REGIONAL REVIEW FINDING

ARC REVIEW CODE: R706111

Submitting Local Government: City of Sugar Hill
Name of Proposal: Sugar Hill Marketplace

Preliminary Report:	June 11, 2007	DEVELOPMENT OF REGIONAL IMPACT REVIEW REPORT	Project:	Sugar Hill Marketplace #1411
Final Report Due:	July 11, 2007		Comments Due By:	June 25, 2007

V/C Ratios

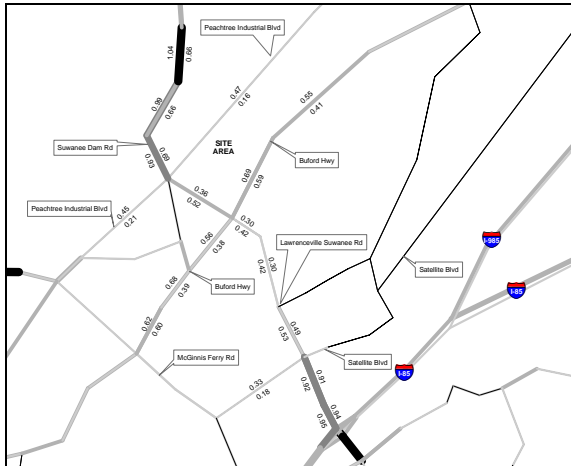
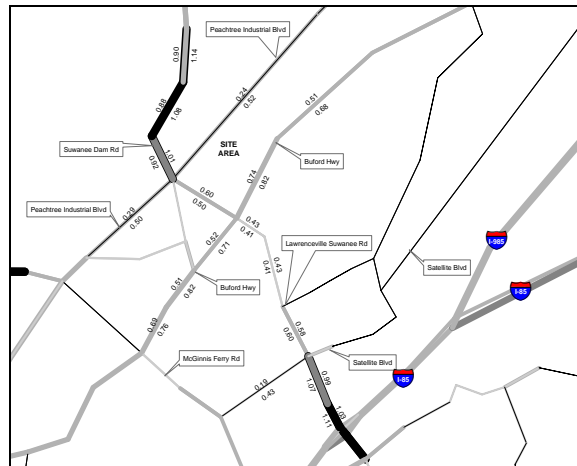
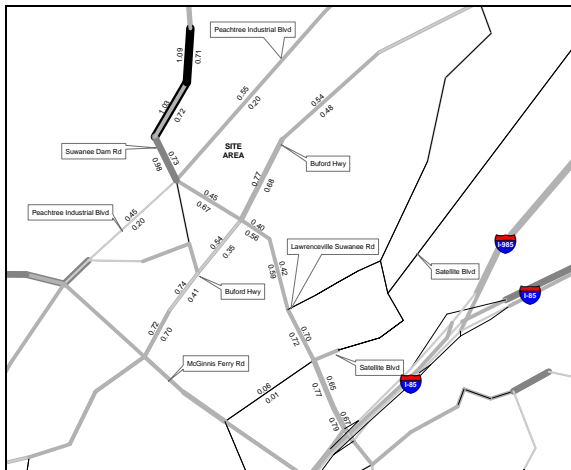
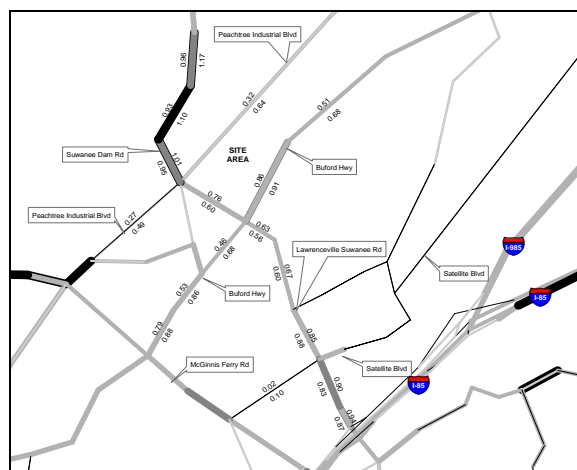
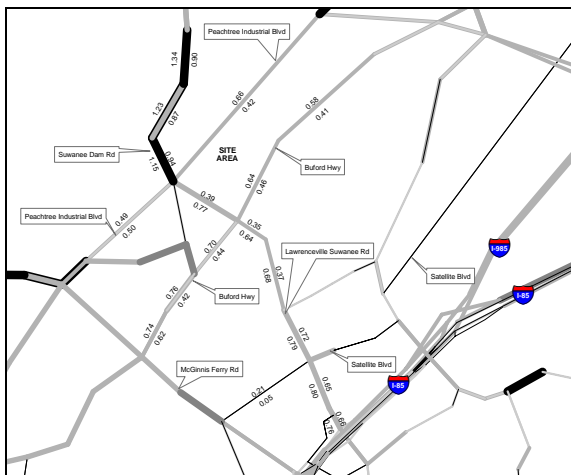
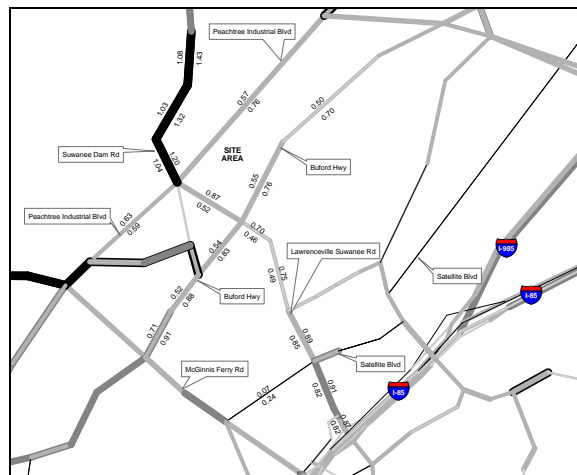
For the V/C ratio graphic, the data is based on 2005, 2010 and 2030 A.M./P.M. peak volume data generated from ARC's travel demand model for Mobility 2030, the 2030 RTP and the FY 2006-2011 TIP, approved in March of 2006. The travel demand model incorporates lane addition improvements and updates to the network as appropriate. As the life of the RTP progresses, volume and/or V/C ratio data may appear inconsistent due to (1) effect of implementation of nearby new or expanded facilities or (2) impact of socio-economic data on facility types.
